CITY PLAN COMMISSION

FILE NUMBER: S234-167

LOCATION: Edd Road, north of Silver Brook Road

REQUEST: An application to create two 0.215-acre lot from 0.429-acre tract of land in City Block 8805 on property located on Edd Road, northeast of Silver Brook Road.

|  1:2,400 | <p>EXISTING AREA ANALYSIS MAP</p> <p> Area of Request  Recent History</p> | <p>Case no: <u>S234-167</u></p> <p>Date: <u>8/2/2024</u></p> |

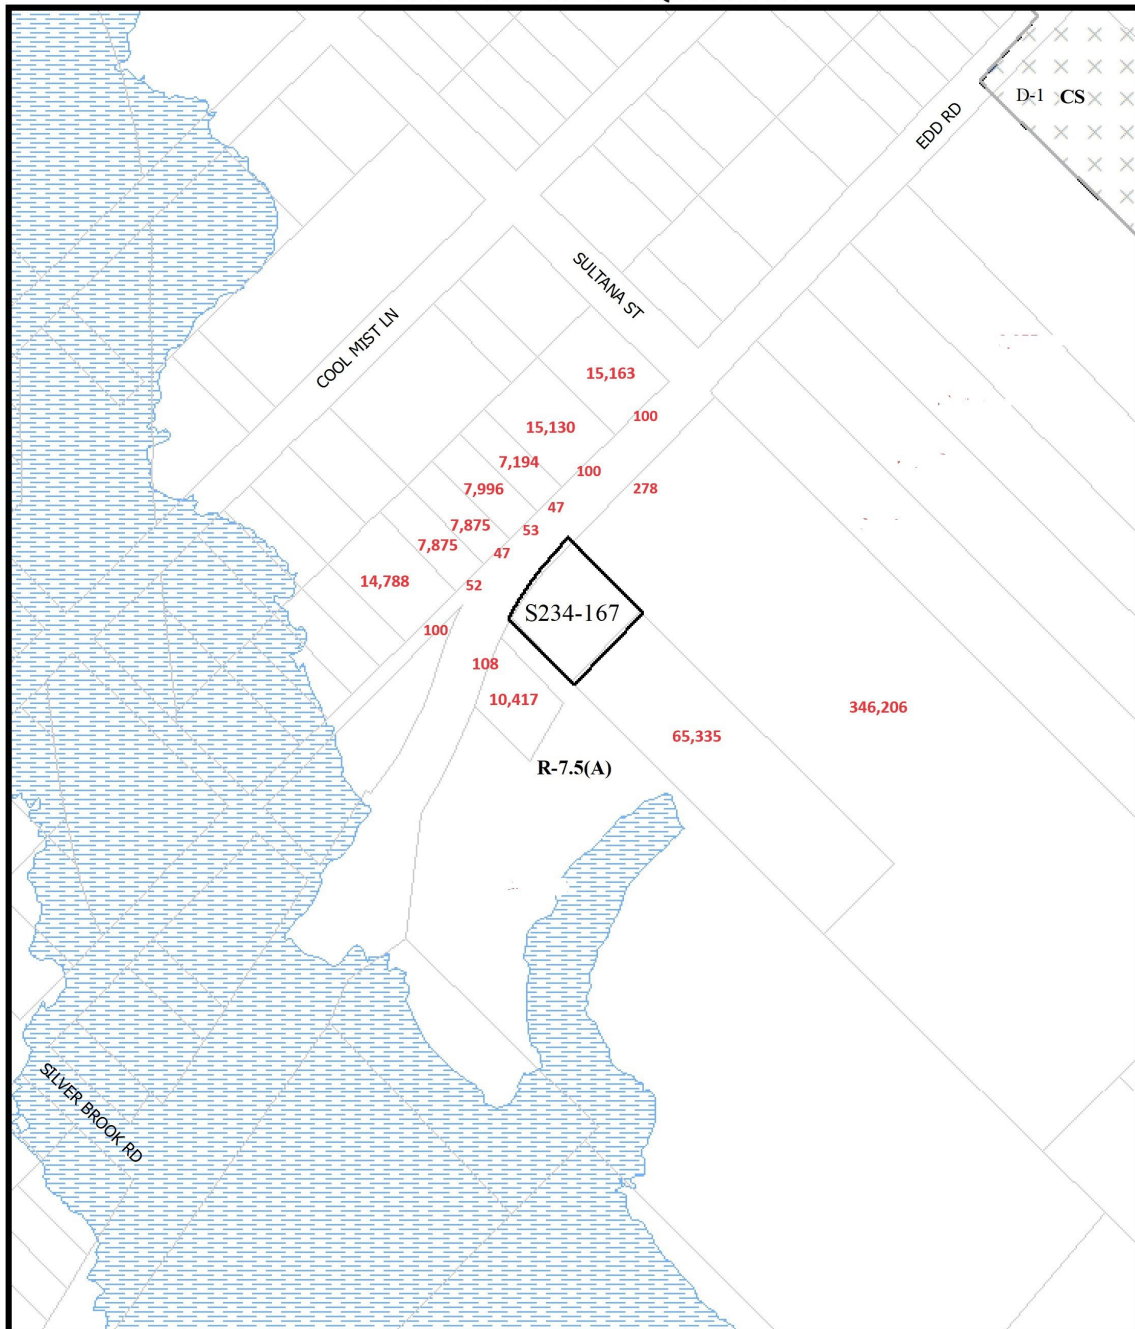
- The properties to the north, east, and south of the request have widths ranging in size from 52 feet to 278 feet and areas ranging in size from 7,194 square feet to 346,206 square feet and are zoned the R-7.5(A) Single Family District. *(Please refer to the existing area analysis)*
